PROPOSED SOCIAL WELFARE FACILITY (RESIDENTIAL CARE HOME FOR PERSONS WITH DISABILITIES) IN "VILLAGE TYPE DEVELOPMENT" ZONE ON APPROVED NAM SANG WAI OUTLINE ZONING PLAN NO. S/YL-NSW/10 AT LOTS 3669 S.A RP (PART), 3669 S.B RP (PART), 3670 RP (PART) AND ADJOINING GOVERNMENT LAND IN D.D.104, NAM SANG WAI, YUEN LONG

Town Planning Application No. A/YL-NSW/348 - Submission of Further Information (3)

**(Planning Application No. A/YL-NSW/348)
Response-to-Comment Table**

FIGURE 2.1
LOCATION OF REPRESENTATIVE AIR
SENSITIVE RECEIVERS

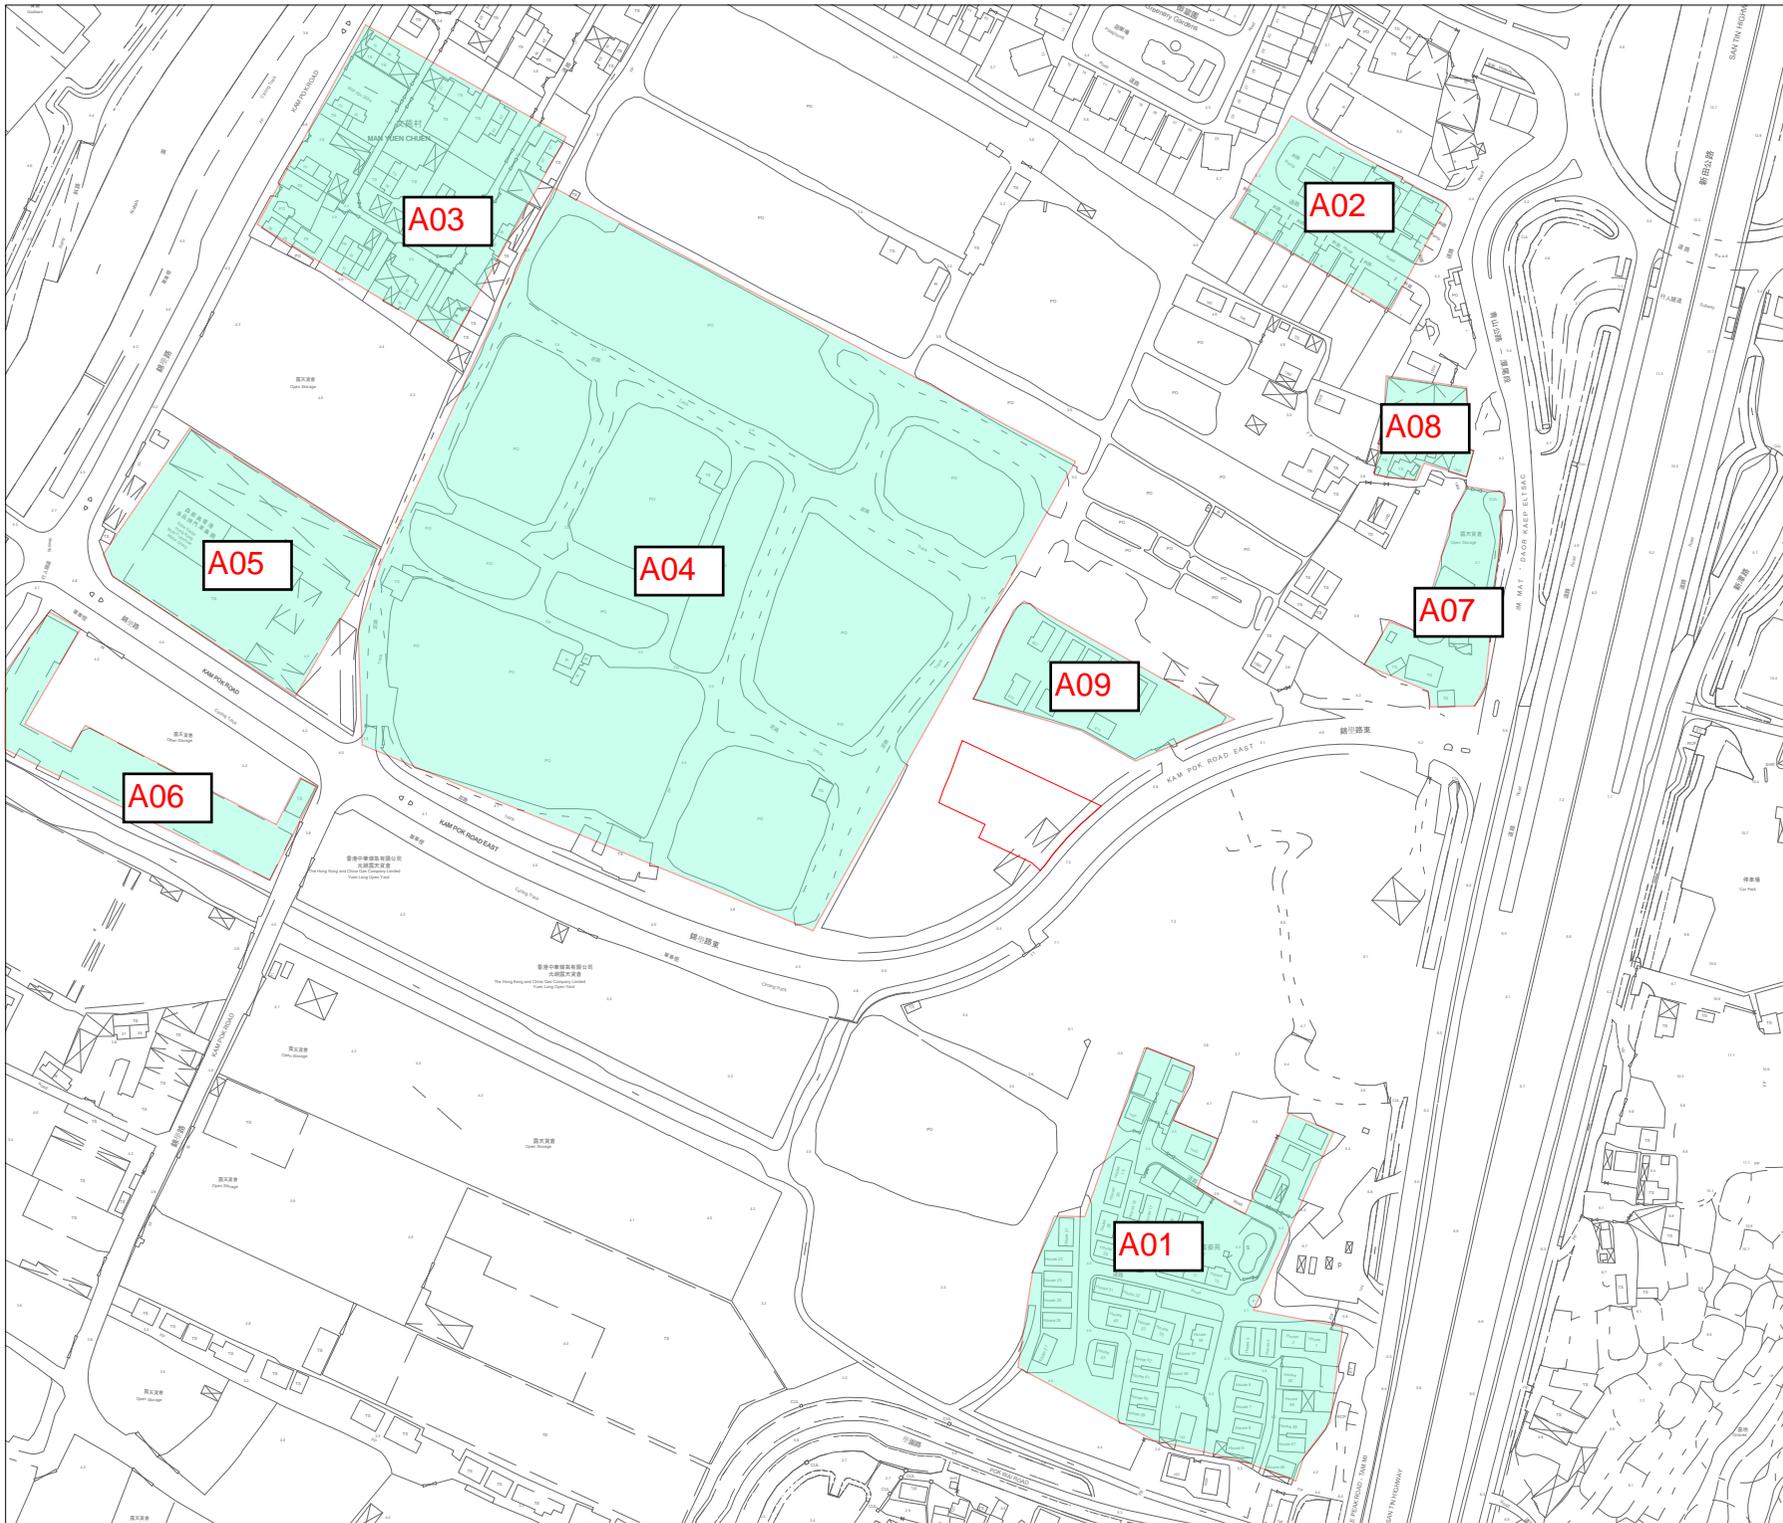
3. Section 2.3.1, Table 2.3 and Figure 2.1 - Please note that not only the domestic premises are the ASRs, some places/premises such as factory and workshop may also be the ASRs. Based on the desktop review, there are some areas in the vicinity of the project site which have been used for workshops/open storage, etc. Please review the potential existing/planned ASRs within the assessment area with reference to the Determination of ASR under the EIAO-TM and update as appropriate.	More ASRs have been identified in Table 2.3 and Figure 2.1. For other areas mainly for open storage use where long duration of exposure to air pollutants is not expected are, therefore, not considered as ASR.

**FIGURE 2.2
BUFFER DISTANCES**

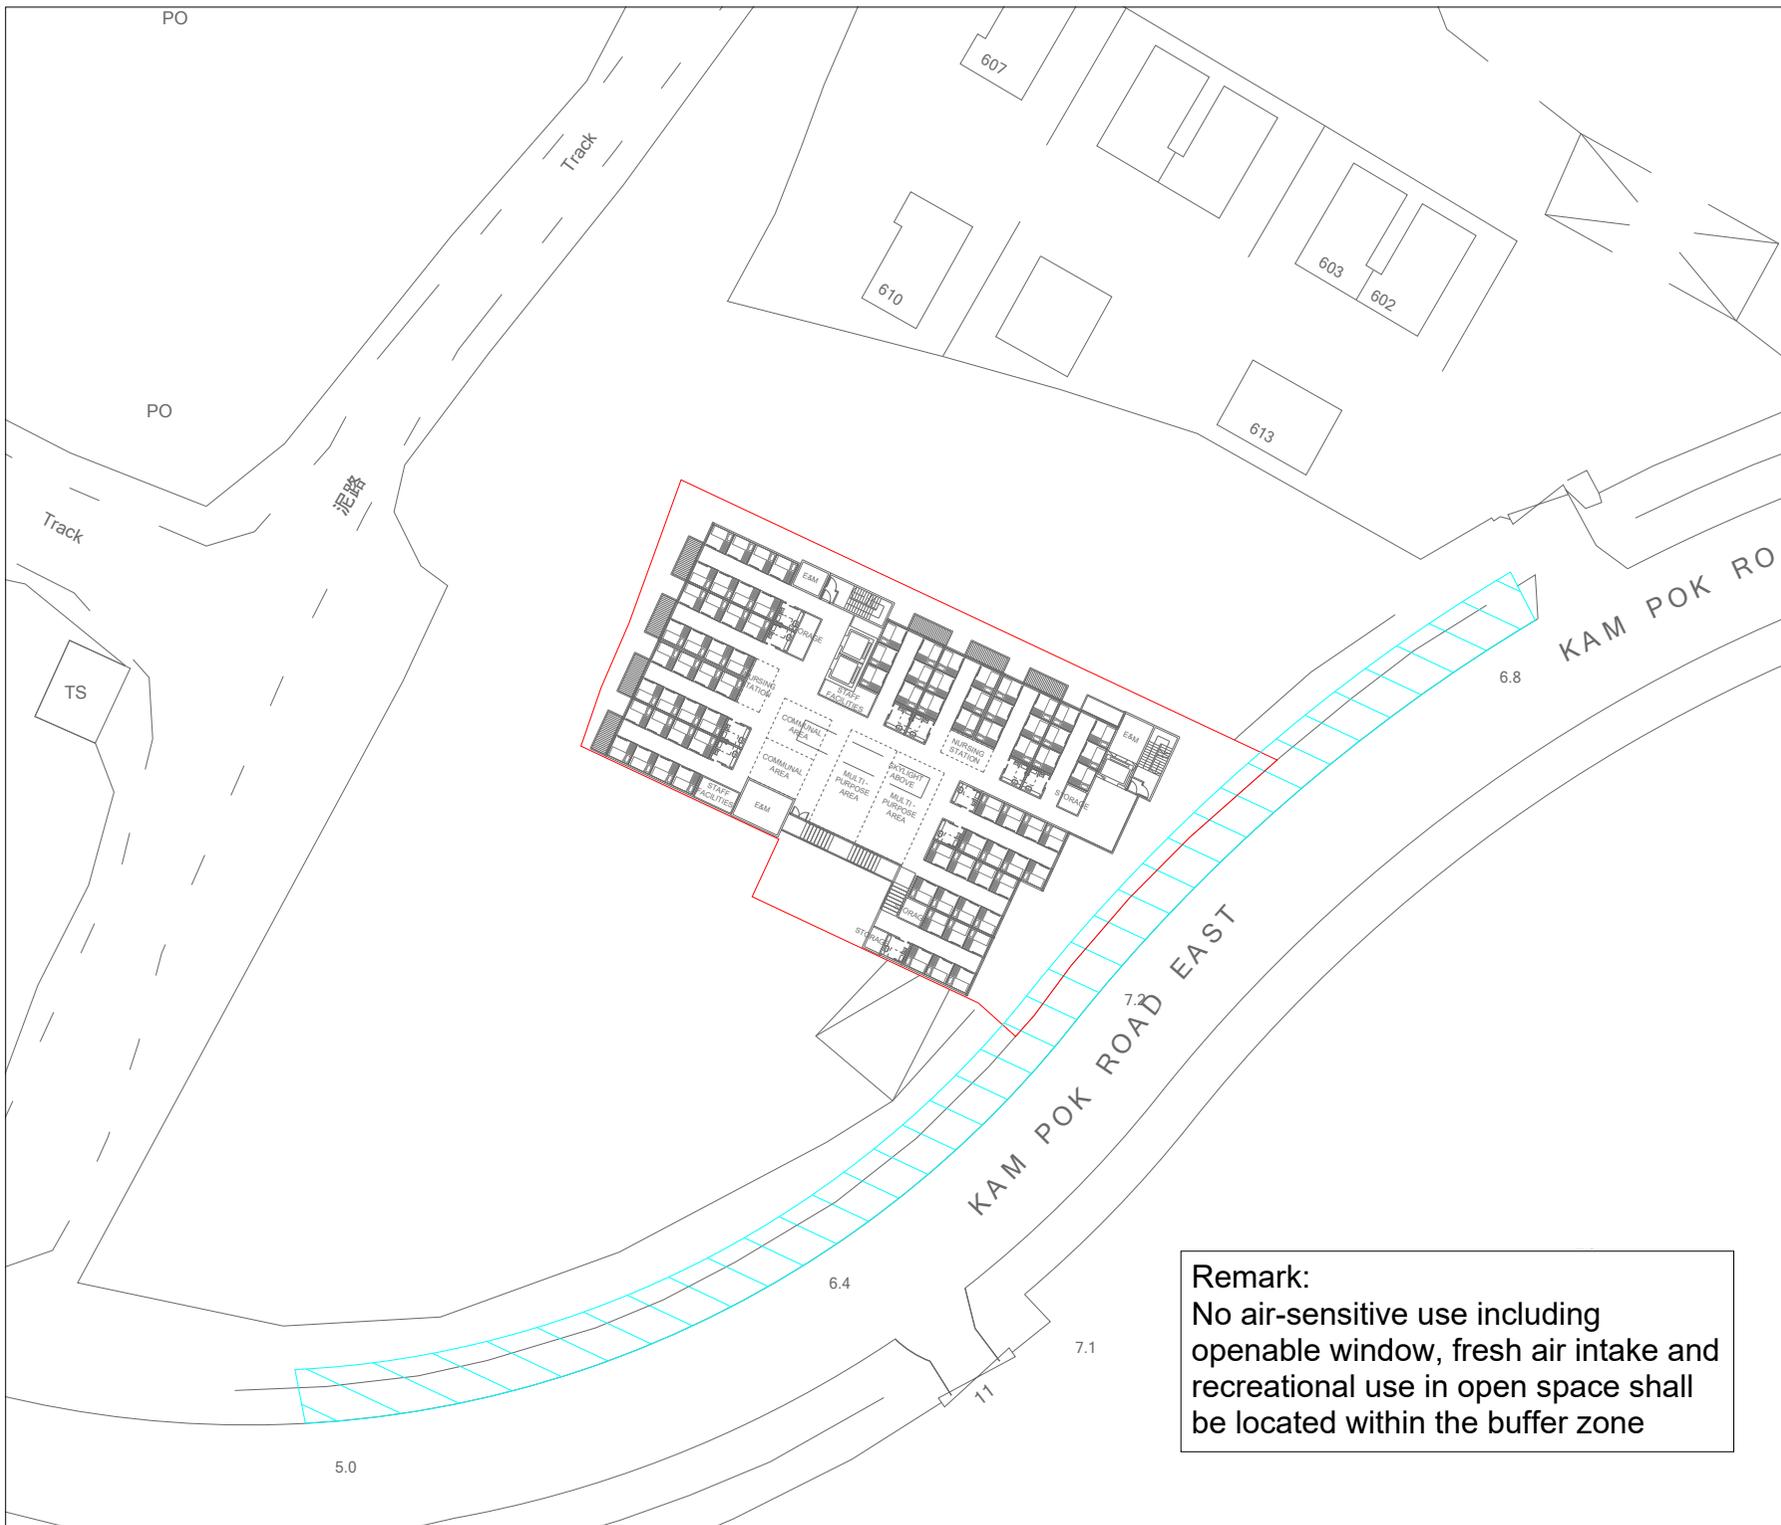
<p>11. Section 2.6.2 - Please supplement this section by incorporating the Comments #8 and #9 above.</p>	<p>The Section is revised accordingly.</p>
<p>12. Figure 2.2</p> <ol style="list-style-type: none"> a. The buffer distance should be measured from the edge of road kerb. Please update and present the buffer zone appropriately. b. Please show the road name of Kam Pok Road East clearly in the figure. c. Please add a remark “No air-sensitive use including openable window, fresh air intake and recreational use in open space shall be located within the buffer zone”. 	<p>Figure 2.2 is revised accordingly.</p>

FIGURE 3.1
LOCATION OF REPRESENTATIVE NOISE
SENSITIVE RECEIVERS

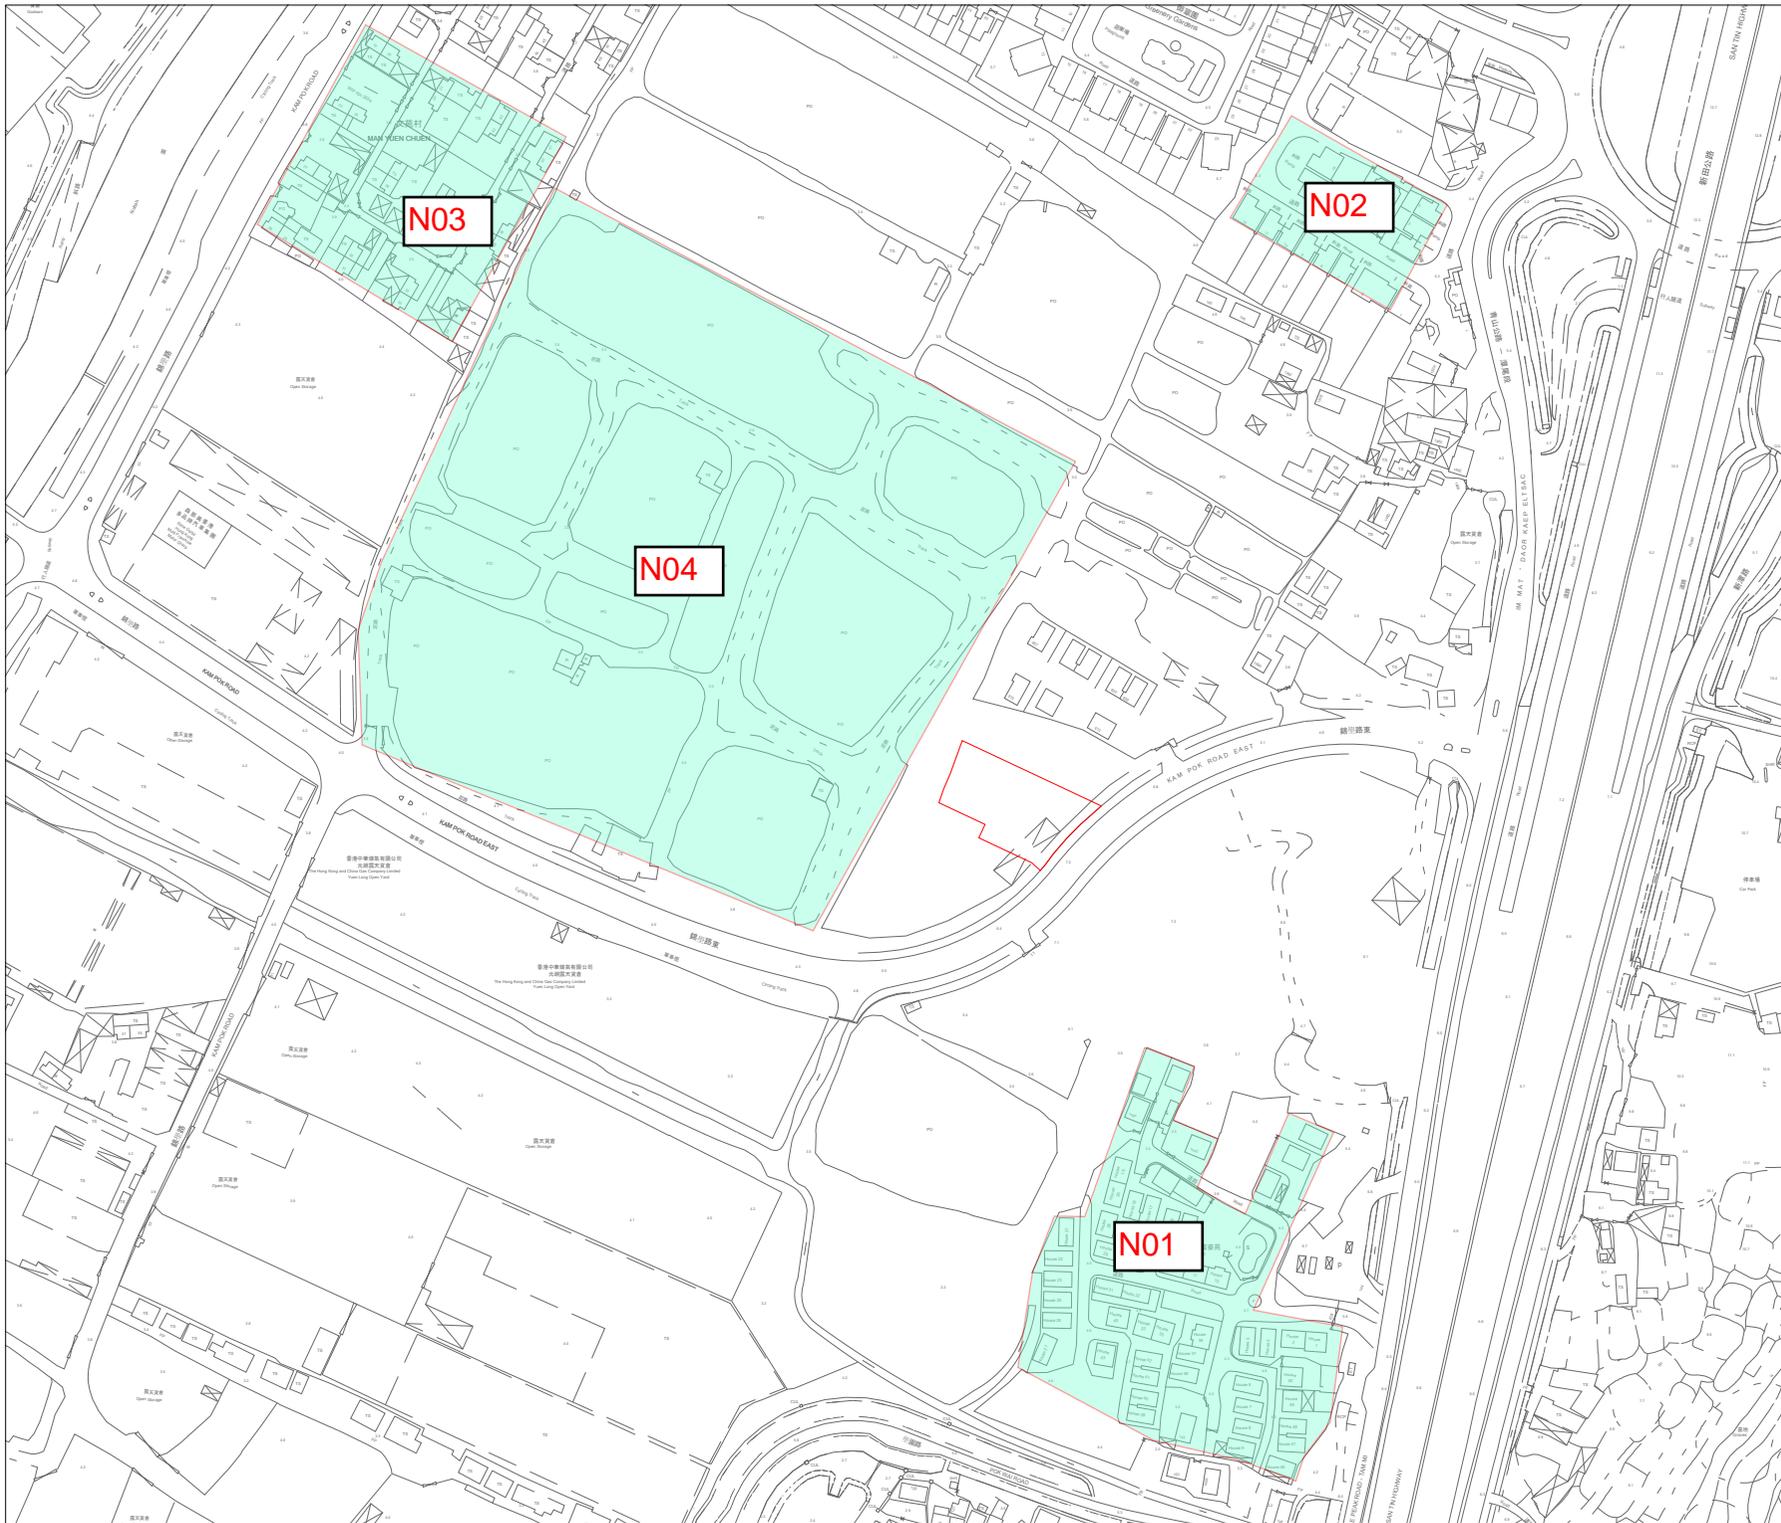
<p>14. Figure 1.1 and Figure 3.1 i. Please separate the site boundary for the projects A/YL-NSW/348 and A/YL-NSW/349 respectively.</p>	<p>The Figure is revised accordingly.</p>
<p>15. Planning statement S6.3.2 i. It is noted in the planning statement that "during the operation stage, air conditioning will be provided for the proposed development and not relied on openable window for ventilation, no adverse fixed noise impact and road traffic impact to the Proposed Scheme is expected". However, this differs from the description provided in the NIA report. Please review this discrepancy. ii. Additionally, even it is equipped with fixed glazed window with installation of air conditioning, a more stringent indoor assessment for fixed noise (10 dB(A) smaller) will be applied to the proposed development. Please note and review.</p>	<p>Please be clarified that air conditioning will be provided for the project while openable window for ventilation is also provided for Dormitory.</p> <p>Noted.</p>

**FIGURE 3.3
LOCATION OF PROPOSED ACOUSTIC
WINDOW**

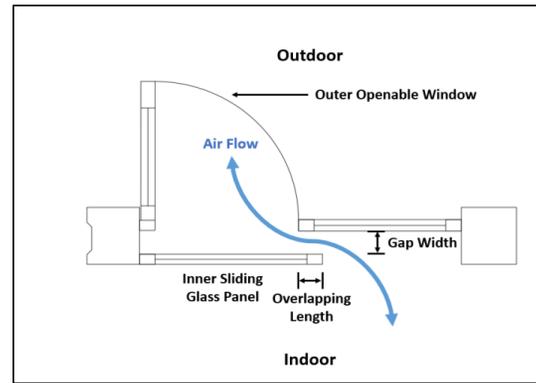
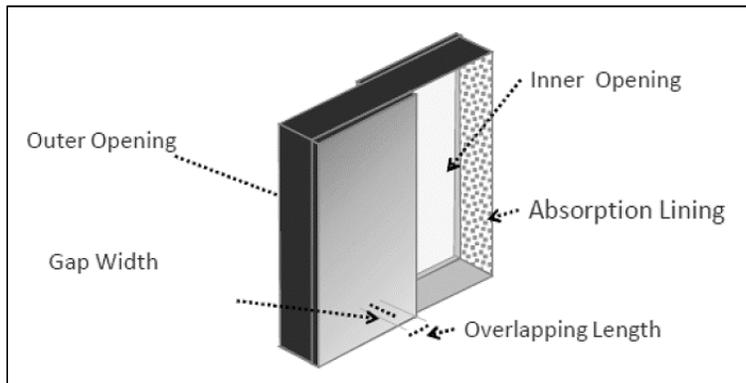
<p>Appendix 3.2 and Figure 3.3, please include these measures in the main text sections S3.4.11 to S3.4.15 where appropriate.</p> <p>ii. In the future NIA submission, based on the updated layout plan, please be advised to explore the application of acoustic windows and acoustic balconies for multi-purpose area too.</p>	
<p>6. Appendix 3.3</p> <p>i. Please supplement the date and time for site survey.</p>	<p>The Appendix is updated accordingly.</p>
<p>7. Appendix 3.4.22</p> <p>i. Please add “(Excluding Container Vehicle)” after the “public parking area”.</p>	<p>The Section 3.4.22 is revised accordingly.</p>
<p>8. Appendix 3.4 and fig 3.4 , S3.4.23</p> <p>i. There is a fixed noise assessment point located at 2F_N07, as indicated in Appendix 3.4. Please include the corresponding fixed noise assessment point in Figure 3.4.</p> <p>ii. Additionally, in the main text section S3.4.23 or any where appropriate, please provide an explanation for the selection of this fixed noise assessment point. It should be clarified if this point was chosen due to it being the most affected direction / the shortest distance to the noise sources.</p> <p>iii. Please also provide the calculation excel sheet for our checking.</p>	<p>The Figure is updated accordingly.</p> <p>The explanation is provided in S3.4.23.</p> <p>Noted.</p>
